ROCHESTER GAS & ELECTRIC CORPORATION

Subject: Technical Requirements Manual (TRM) Revision 18

Technical Requirements Manual TRM

Revision 18

Figure TRB 3.7.7-1
SFP Cooling System

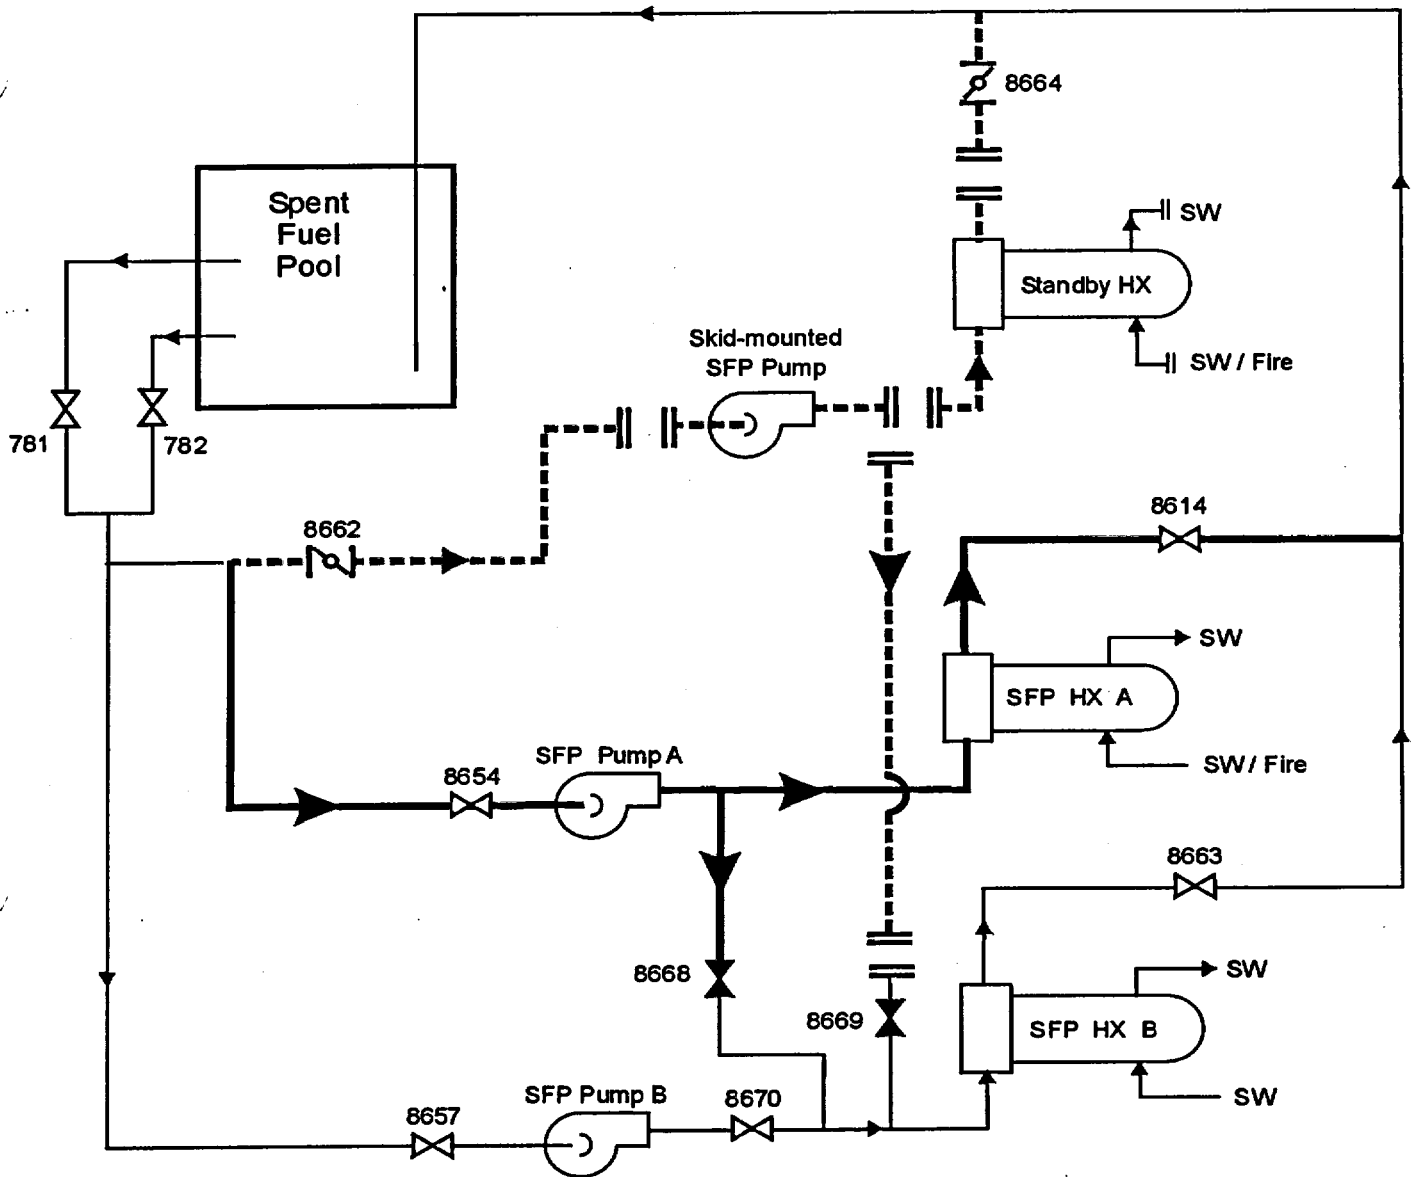
TRM sections TR 3.7.7, Spent Fuel Pool (SFP) Cooling System, and TR 3.9.4, Full Core Offload for Cycle 27, will be revised to provide the changes associated with PCR 2001-0036 and the Cycle 29 core offload. PCR 2001-0036 provides the ability to cross-tie the A SFP pump and/or the Standby SFP pump to the B SFP heat exchanger. Analysis has been generated supporting the timing of the Cycle 29 core offload.

The SFP Cooling System consists of three SFP pumps, two installed SFP heat exchangers, one SFP Standby Heat Exchanger (which is not normally used), and associated piping, valves, and hoses (see Figure TRB 3.7.7-1). The flow path starts at the common suction from the spent fuel pool to the three SFP pumps, through one or more SFP pumps and one or more SFP heat exchangers, and to the spent fuel pool via the common return line. The primary loop (SFP Loop B) is made up of the SFP Pump B, SFP Heat Exchanger B, and piping. The backup loops include:

There is also the ability to align the SFP Pump A and SFP Standby Pump individually or in parallel to the SFP Heat Exchanger B. Service water (SW) circulates through the shell while SFP water circulates through the tubes of the SFP heat exchangers. There is also the ability to provide fire water for cooling of the SFP Heat Exchanger A and SFP Standby Heat Exchanger. SFP Cooling System Loop B is sized for 100% of the design SFP heat load. SFP Loop A and the SFP Standby Loop are each capable of removing the normal basis heat load. When the SFP Pump A and the SFP Standby Pump are operated in parallel, through either their designated heat exchangers or through the SFP Heat Exchanger B, they can remove 100% of the design heat load (Ref. 1). Motor-operated valves provide automatic and remote manual isolation of the SW supply to the SFP heat exchangers. These valves close automatically upon coincidence of safety injection and loss of offsite power. Handwheels are provided for manual operation.
